Office Action Summary

17/018,099

COLIN W STUART

FIG. 11A

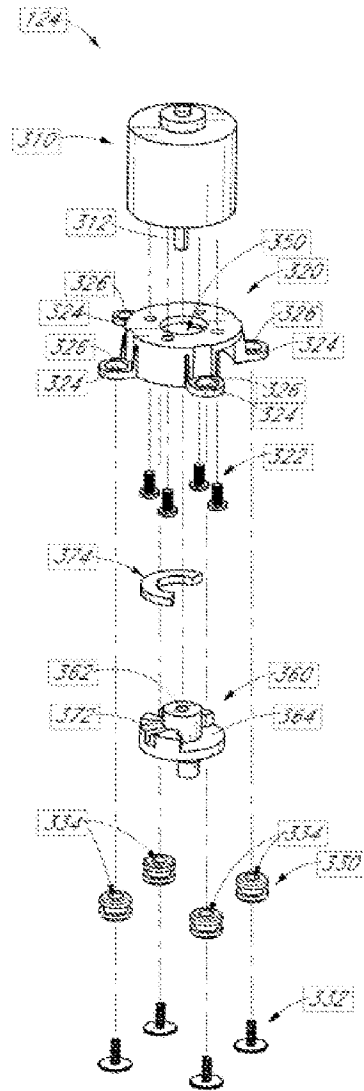
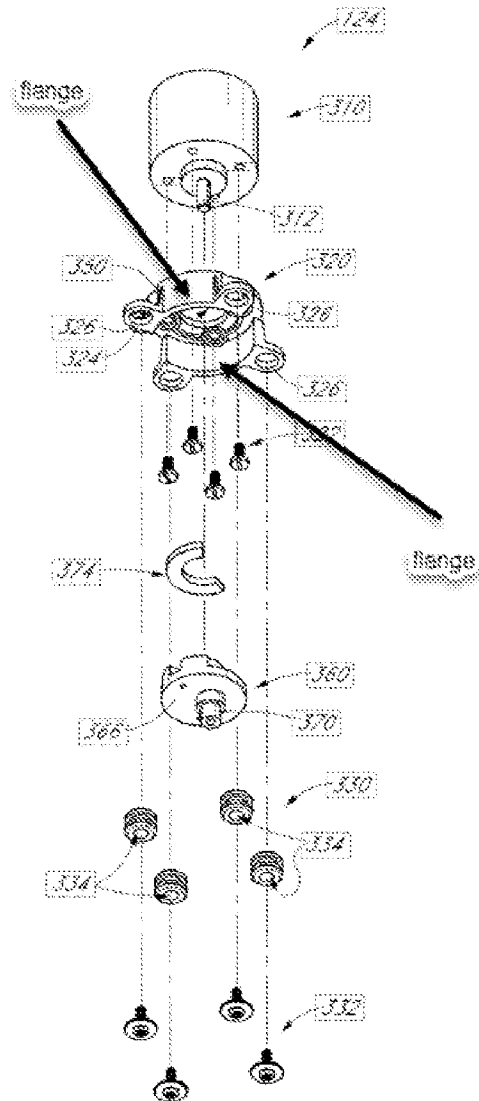
Regarding claim 2, the modified Pepe device teaches a motor (see Pepe para. 0026), but is silent as to the motor being a brushless motor with a rotatable motor shaft, wherein the percussive therapy device further comprises a motor mount positioned in the housing, wherein the motor mount includes a mounting wall having a shaft opening defined therein, wherein the motor is mounted to the mounting wall and the motor shaft extends through the shaft opening, wherein first and second mounting flanges extend from and extend perpendicular to the mounting wall, and wherein the first and second mounting flanges are secured to opposite sides of the housing. However, Marton teaches a similar device which includes a brushless motor with a rotatable motor shaft (see Marton Fig. 3, motor 310, see col. 9 ln. 60), wherein the percussive therapy device further comprises a motor mount positioned in the housing (see Fig. 3 and 11A-B, motor mount 320, col. 10 ln. 1-21), wherein the motor mount includes a mounting wall

having a shaft opening defined therein, wherein the motor is mounted to the mounting wall and the motor shaft extends through the shaft opening (see Fig. 11A-B, mounting wall being the upper wall of 320 which motor 310 directly attaches to, shaft opening 350 through which the motor shaft 312 extends), wherein first and second mounting flanges extend from and extend perpendicular to the mounting wall, and wherein the first and second mounting flanges are secured to opposite sides of the housing (see annotated Fig. 11B below). Thus it would have been obvious to one of ordinary skill in the art before the effective filing date of the claimed invention to modify the modified Pepe device's motor to explicitly be a brushless motor and to mount to the housing via the motor mount, as taught by Marton, in order to provide improved efficiency of the motor and thus the device and to provide required structural elements to secure the motor in the housing.
